## **DELEGATED DECISIONS BY CABINET MEMBER FOR TRANSPORT MANAGEMENT**

### **GROVE: DENCHWORTH ROAD / THE MAPLES – PROPOSED TRAFFIC CALMING FEATURE**

**Report by Director of Environment and Highways**

Job Title	MONKS FARM, GROVE	Scale	1:500@A3	Date	SEP 24	Designed	
Drawing Title	RAISED TABLE JUNCTION LAYOUT (TRO)	Drawn	EW	Checked	RP	Approved	SW
Client	DAVID WILSON HOMES SOUTHERN	Job No	21-104	Drawing No	21-104-414	Rev	A

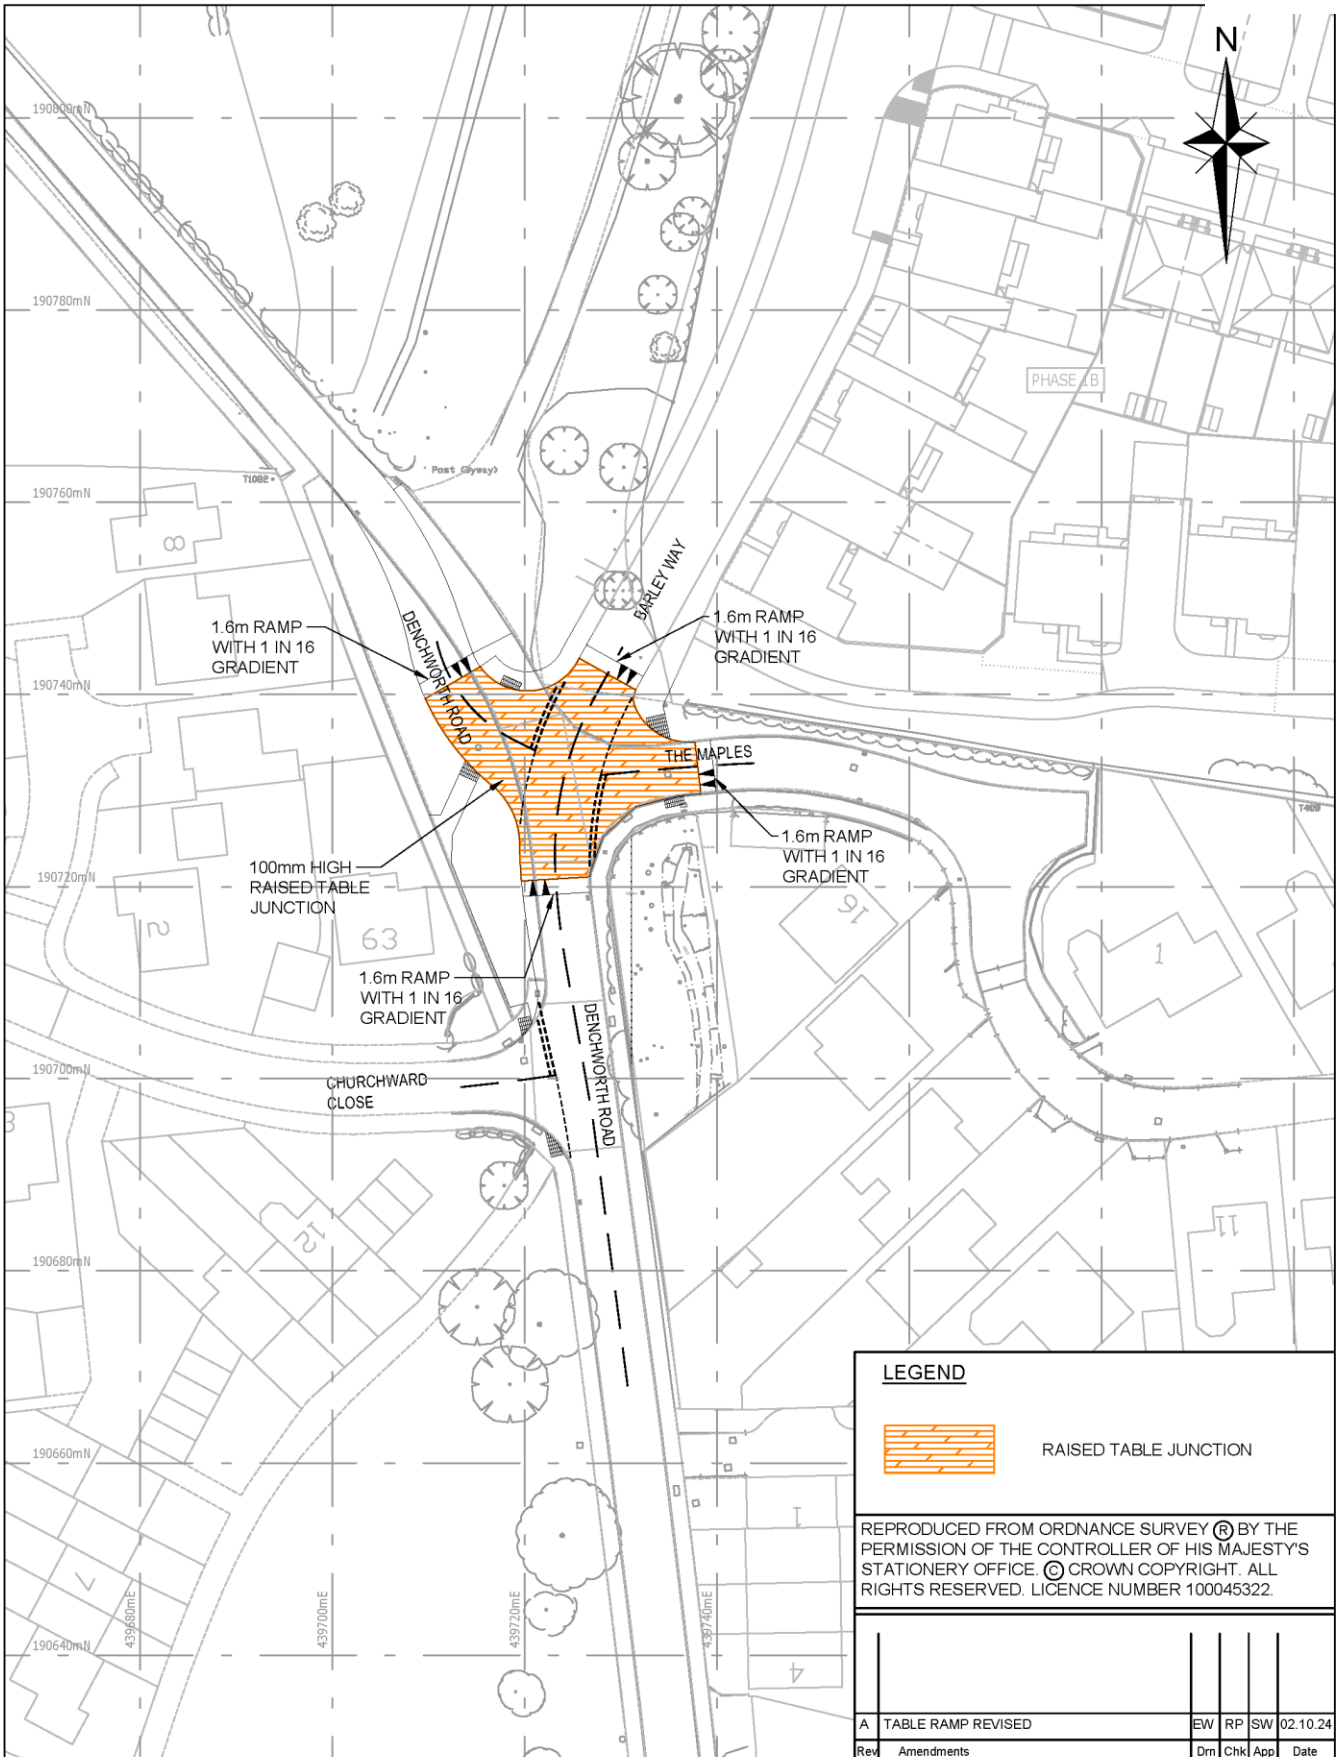
1. This report presents responses received to a statutory consultation on proposals to construct a new Raised Table (including 2 metre ramps, with heights of 100mm & gradients of 1:16) traffic calming feature at the Denchworth Road/The Maples/Barley Way junction (extending into each by approx. 15 metres), as shown in **Annex 1**.

(4) Local resident, (Grove, Churchward Close)	<p><b>Object</b> – A similar traffic calming method exists elsewhere in Grove and has proved completely ineffective. The only method that may succeed as a speed control measure is to install a mini roundabout at the junction of the three roads</p>

(13) Local resident, (Grove, The Maples)	<p><b>Object</b> – The raised tables do not work at slowing down the boy racers and they will continue to zoom over them at well over the speed limit. It's also very confusing about who has right of way for people going into The Maples vs</p>

people coming out of Barley Way so the only real solution is a mini roundabout to make it very clear to all road users, and to force everyone to slow down.

The residents have argued from the beginning that the only viable solution is a raised roundabout at the junction which will force all traffic to slow and give way to other road users from the right. The slowing effect of a raised roundabout will also assist pedestrians crossing the road.

<p>Barley Way is the main route. This may have the welcome effect of de-emphasising the road to Denchworth as a rat run. We are glad to see this proposal, but we are not sure it is sufficient. In particular, when cycling from Denchworth into Grove, there will now be a dangerous right turn across potentially busy traffic. Perhaps a small roundabout might be better?</p>
<p>(27) As part of a group/organisation, (Wantage &amp; Grove, Mill Street)</p>	<p><b>Partially support</b> – I am responding on behalf of the Wantage and Grove Active Travel (WAGAT) group. We support measures to improve road safety for all and welcome the recognition that the current arrangement needs improvement.</p> <p>We note the documentation only mentions making it safer for pedestrians. Safety for cyclists as well as those in wheelchairs and mobility scooters should also be kept in mind.</p> <p>We note that with the ongoing housing developments this will become a junction within an urban area, and is expected to become yet busier. Furthermore Denchworth Road leading towards Denchworth village is popular with cyclists as one of the overall safer cycle routes out of Wantage &amp; Grove.</p> <p>We are aware that the original plans state that Barley Way would only be a short road providing access to a limited number of houses. However, we also understand that as a temporary arrangement it will provide a through route to the A338 and northwards. We support Barley Way returning to its original function as a quieter road that can still provide through access for active travel. On this:</p> <ul style="list-style-type: none"> <li>o In either case Barley Way will provide an important route for pedestrians/wheelers/cyclists to travel between the Monks Farm development and facilities in Grove and Wantage further south.</li> <li>o Should Barley Way remain open for through traffic it is likely to become very busy. However, the cycle lane along Barley Way ends just north of this junction and we would then like to see other improvements to the provision for active travel.</li> </ul> <p>It is not clear to us whether a raised table will significantly reduce traffic speeds. There is currently a 30mph limit across this junction. We would like this reduced to 20mph.</p> <p>Despite specifically mentioning the concern about pedestrian safety there are no refuges provided for pedestrians to cross the roads. Indeed there is a path shown across the western arm of the junction to provide access towards the Cow Lane path - but even this has no safe refuge for crossing the road.</p> <p>We are aware of a response from those living very close to the junction who propose a roundabout at this point. This seems to us to be a viable improvement. (E.g. a compact roundabout as in LTN 1/20 Section 10.).</p>

The exit from The Maples is on the inside of curve of the Barley Way - Denchworth Road part of the junction. It is not clear from the plan whether the sight lines for vehicles and cycles exiting The Maples are adequate.

13. The raised table was included within the design during the technical approval process. A stage 2 Road Safety Audit was undertaken, and the Road Safety Auditor recommended a raised table to be introduced to slow speeds at the Denchworth Road junction, the Road Safety Auditors recommendations were supported by Oxfordshire County Council and if approved will be works will be implemented by the developer.

14. At all approaches to the junction the raised table spans the full width of the carriageway to ensure vehicles slow down sufficiently. The junction priority has been changed with the appropriate signage informing road users.
